SANDY SPRINGS
GEORGIA

P&Z STAFF REPORT

Board of Appeals Meeting, December 10, 2019

Case: **V19-0022 – 0 Glenridge Drive**
Staff Contact: Madalyn Smith (msmith@sandyspringsga.gov)
Report Date: December 3, 2019

SHEET NUMBER
C3.00

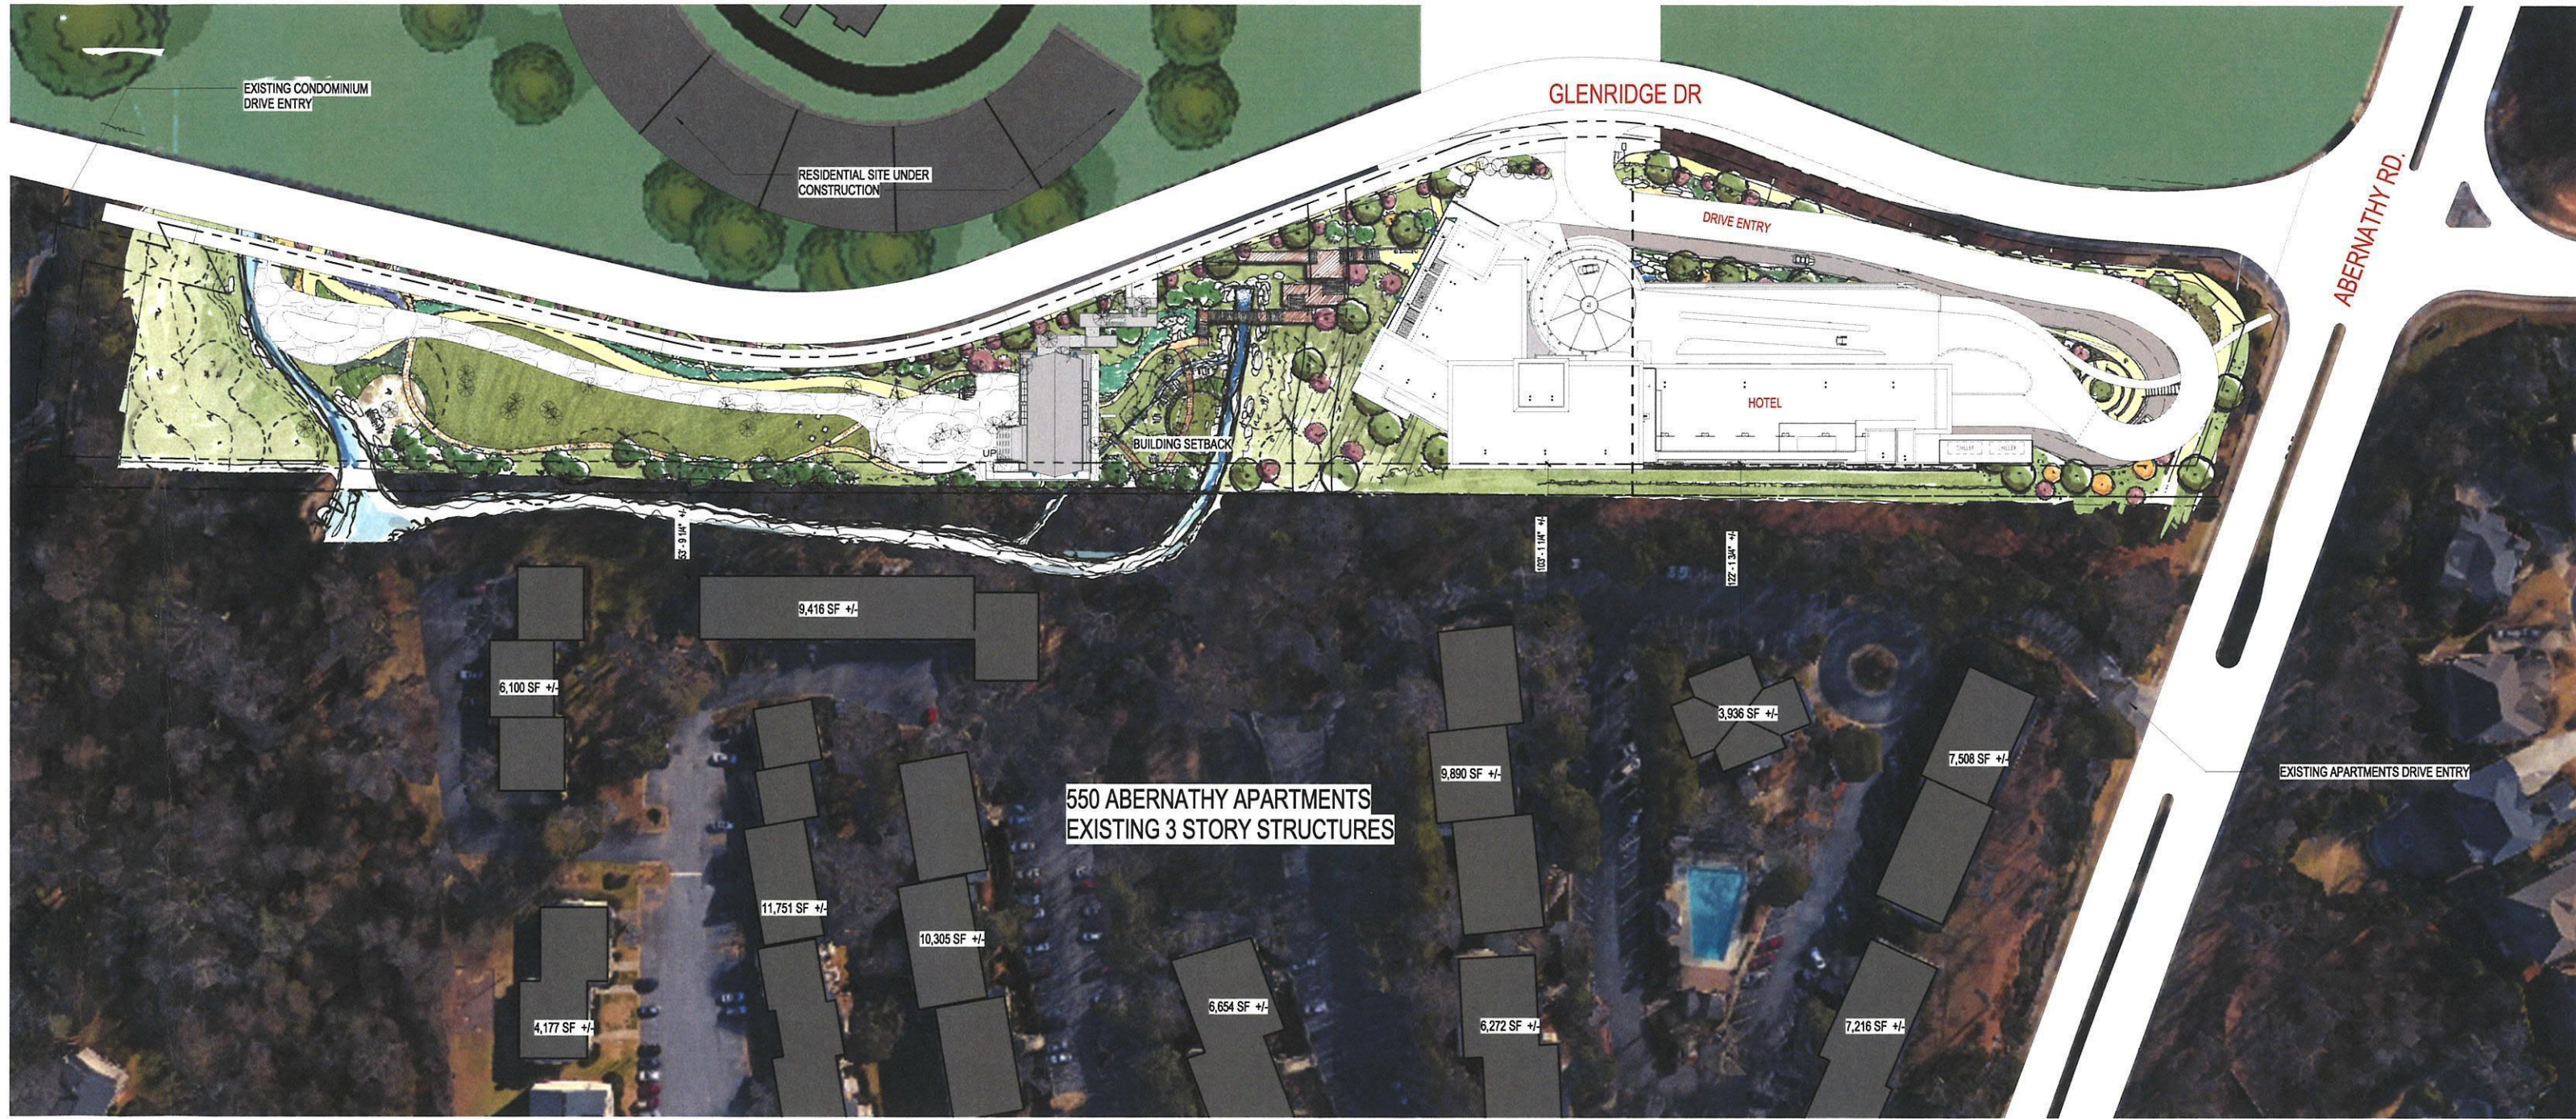
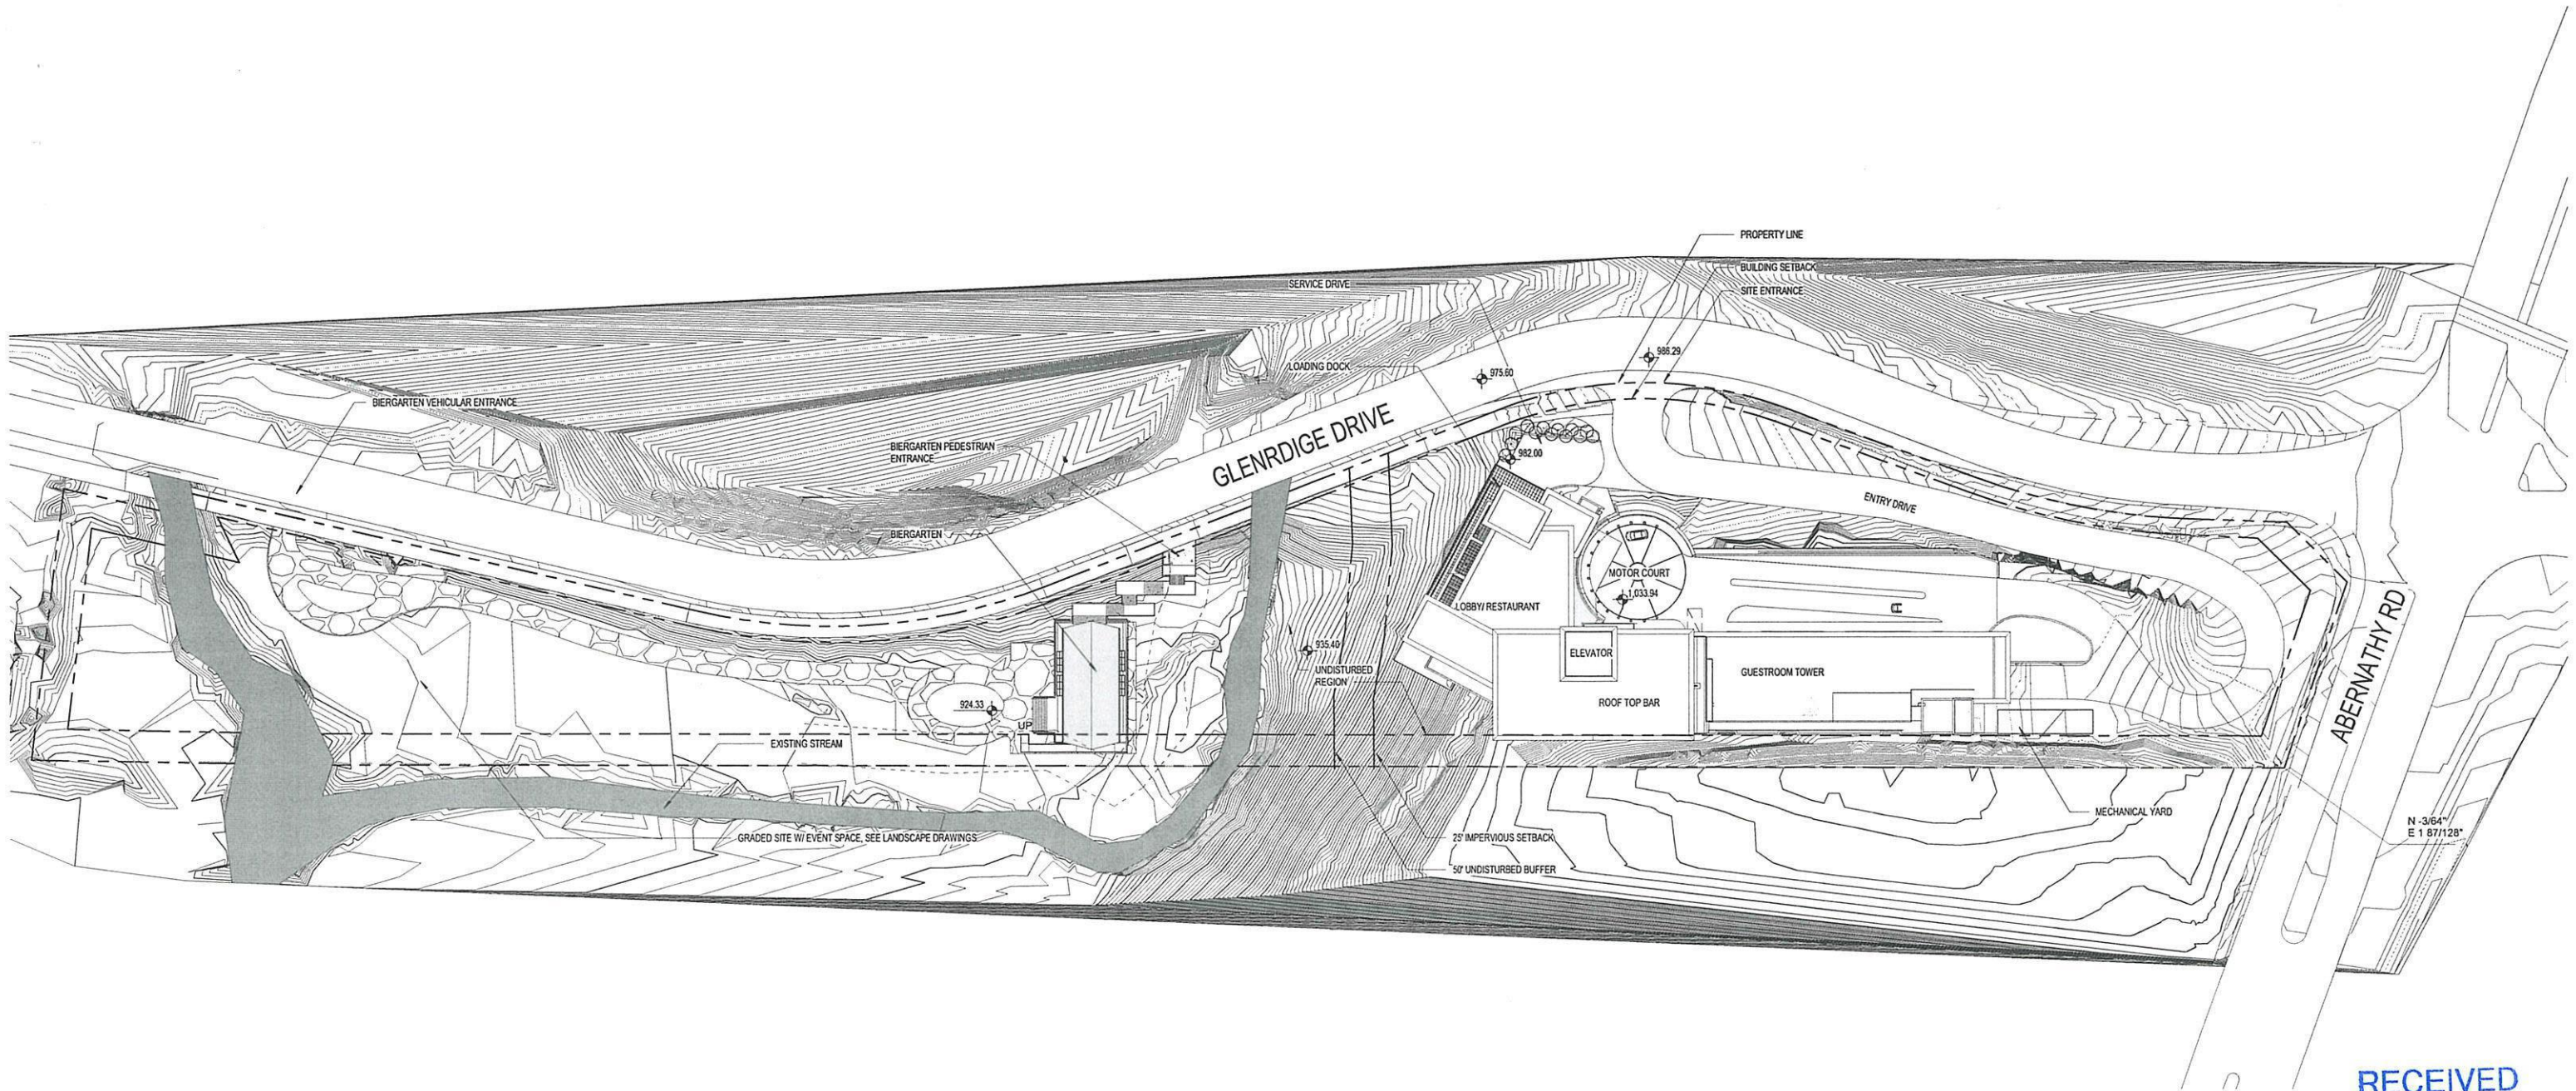
The retaining wall is 33 feet tall out of necessity. Without the retaining wall, access to the site is not possible. For this reason, Staff finds the request to be the minimum relief necessary.

Given the amount of rise on the site and its narrowness, the heights of the retaining walls seem inevitable, if our primary goal is to have developments work with their sites' natural topography. The wall height provision is a generally valid one from both an aesthetic and environmental points of view. However, in this case, just as with many mountain roads, the taller retaining walls, properly treated, seem both inevitable and natural.

Concerning the retaining wall height, the retaining walls seem necessary based on the topography of the site; however, the applicant should show a diverse landscape plan to be installed to help block the sight of the walls as much as possible.

1. The height of the retaining wall be substantially similar to that shown on the “*Mayson House Variance Issuance*” plans received October 28, 2019 and subsequent amendments received November 6, 2019.
